# Mask Set Errata for Mask 2L87X

This mask set errata applies to the mask 2L87X for these products:

- MC68HC908QB8

**Figure 1. Maximum Time for Other Execution**

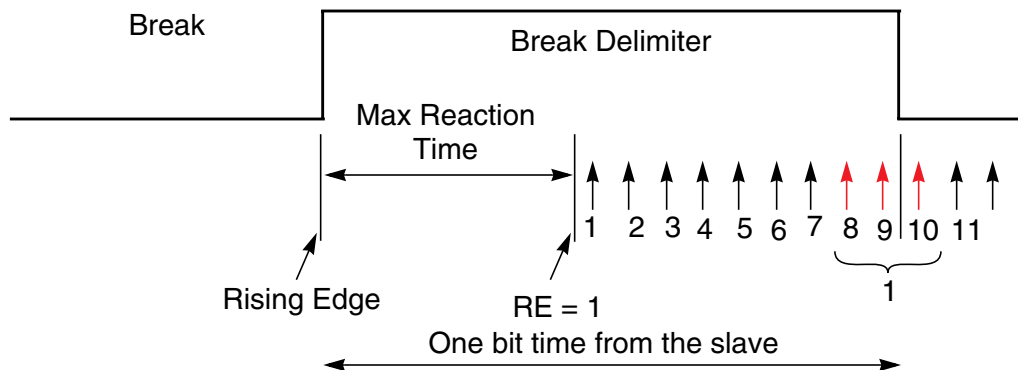
The time between when the rising edge actually appears on the receive pin and when the receiver is switched back on is finite and is governed by the timing of the falling edge of the delimiter. The receiver must be switched back on no later than 9/16th of a bit time before the end of the delimiter. See [Figure 1](#).

From Figure 1, we also see that the “Maximum Reaction Time” is 7/16<sup>th</sup> slave bit-time.

Translating that into an example LIN system yields:

One bit time at 19200 bps is 52.1  $\mu$ s.

The LIN 1.3 specification indicates the slave can run at 14% and the master at 0.5% of the nominal baudrate. The smallest bit-time the slave might observe is (accounting for accumulated timing errors of a slow slave and fast master):

$$(100\% - 14.5\%) \times (52.1 \mu\text{s}) = (0.855) \times (52.1 \mu\text{s}) = 44.5 \mu\text{s}$$

The Maximum Reaction Time for this example system is  $7/16 \times (44.5 \mu\text{s}) = 19.47 \mu\text{s}$ .

From the instant the rising edge appears on the receive pin (detected via the arbiter AFIN bit or a timer interrupt), the software has to switch the receiver OFF and back ON within 19.47  $\mu$ s.

Because ground shift in the physical layer might also affect the timing of the falling edge of the START bit of the 0x55 synch byte (i.e., the end of the delimiter), best design practices suggest that the switching of the receiver should be done as quickly as possible after the rising edge is detected. The maximum reaction time calculated above should be treated as a guideline only.
